Urban Design Changes

Pearl Lofts

12.14.21

First UDPRP Review: May 21, 2021

Garage Screening

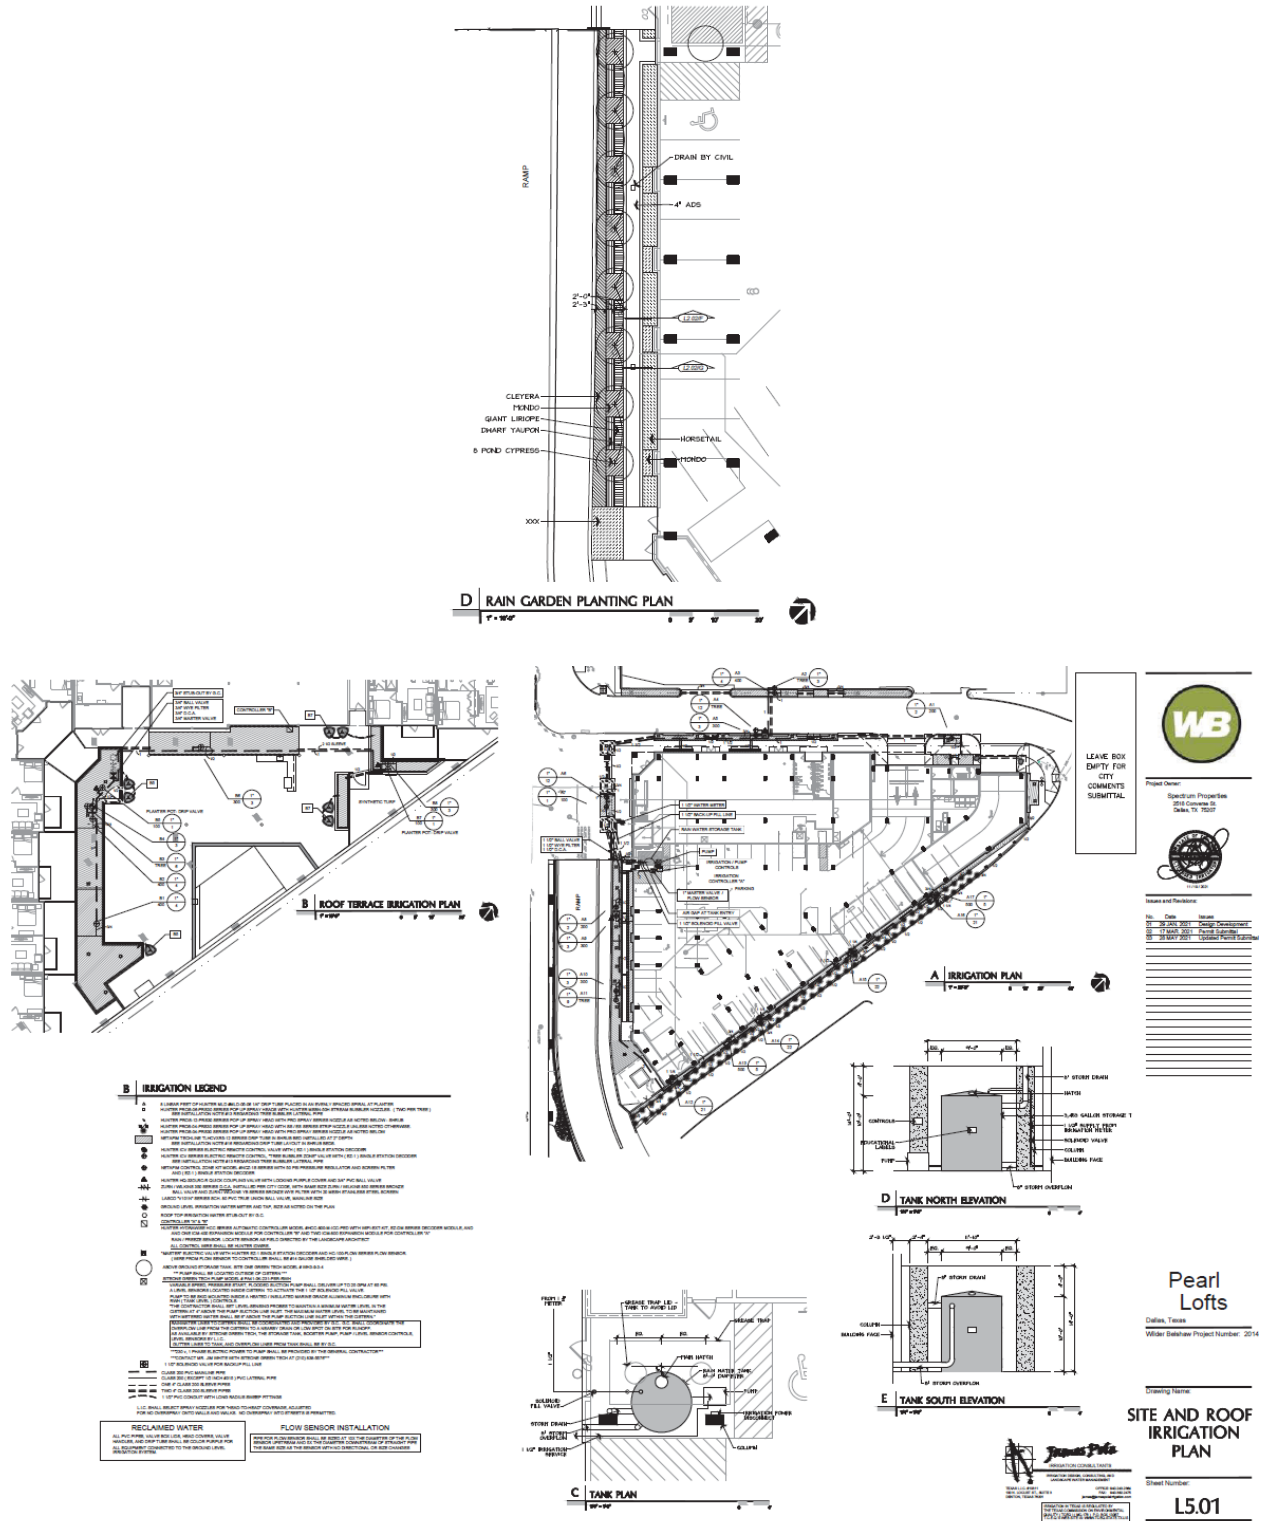
7. The Panel suggests further design refinement be given to the design of the parking garage façade on all sides to further screen the parking uses and improve the proportionality between openings on the First and Second floors.

5. The Panel notes a lack of notable change in the garage façade design facing Pearl Street and Jan Pruitt Way, highlighting the need to better reflect recommended changes noted in the first review.

Before: Garage was not screened on the rear, and along Pearl Street ROW and Jan Pruitt Way, it was not reflective of the remainder of the façade on the front of the building

After: A green/vegetated screening wall was added to the rear façade to soften the edge in the interim and better interact with a future open space. Additional façade enhancements were added on the other garage facades to better screen the parking.

Relation with Future TXDOT Improvements

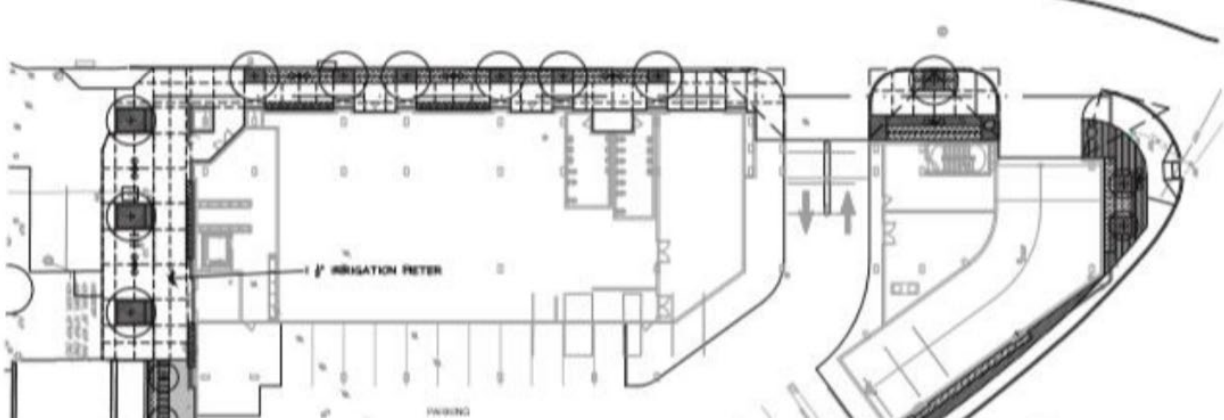
2. The Panel recommends that more thought be given to the way this development interfaces with the removal of Cesar Chavez, including providing a potential Phase II diagram. Another possibility is a future extension of the proposed garage to allow for new retail/office along the Pearl Street frontage.

Before: Initial site plan

After: Diagram showing how Pearl Lofts might interface with new developable property

Streetscape and Plaza Enhancements Along Jan Pruitt Way

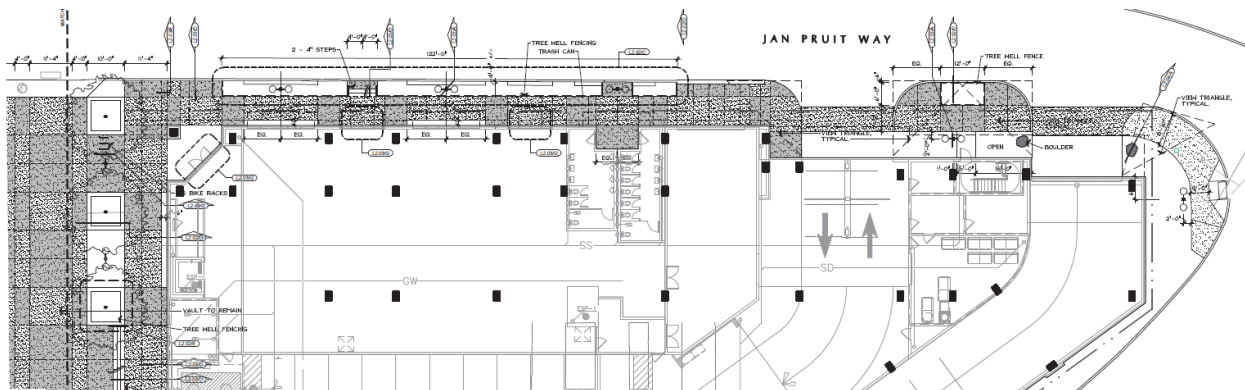
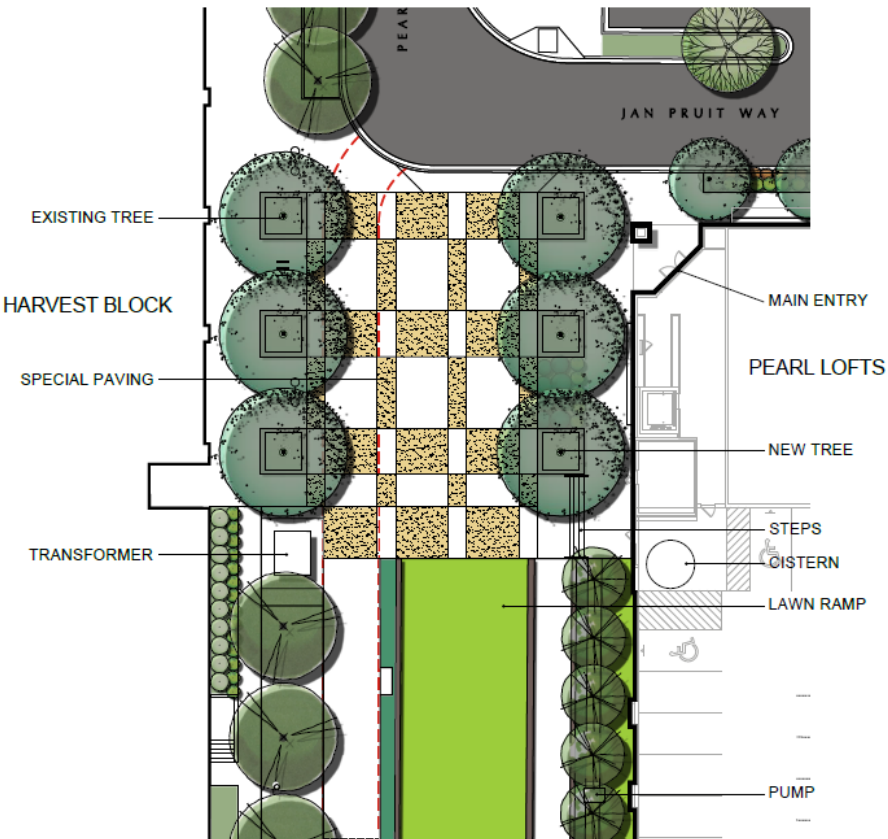
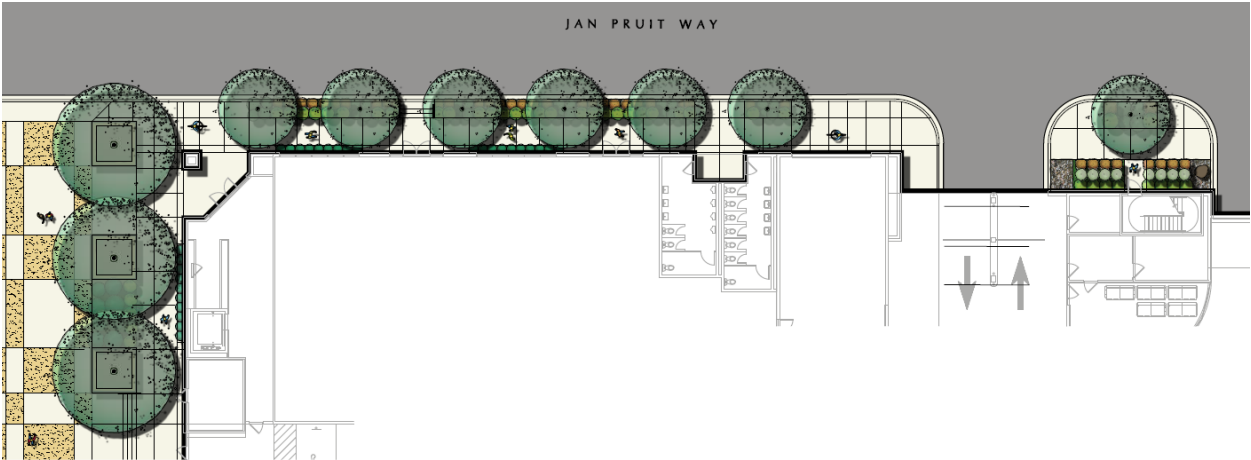
6. The Panel recommends that further design refinement be given to the streetscape along Jan Pruitt Way to create a more inviting pedestrian space, including replacing the landscape buffer with tree wells and giving more focused design to the driveway entries into the garage.

6. The Panel recommends further thought be given to how loading will occur in the proposed plaza, considering the need to treat this as a people-oriented space.

Before: The treatment of the plaza area at the terminus of Pearl Street was not considered. Additionally, the streetscape along Jan Pruitt Way needed improvements in terms of dimensions and treatments across driveway entrances.

After: Improvements were made to the plaza at the terminus of Pearl Street, considering its need to accommodate pedestrians and provide uses such as food trucks but also still need to serve as a loading zone for the Harvest Lofts in the future. Additionally, improvements were made across the site's two driveways to create one uniform pedestrian experience and level.
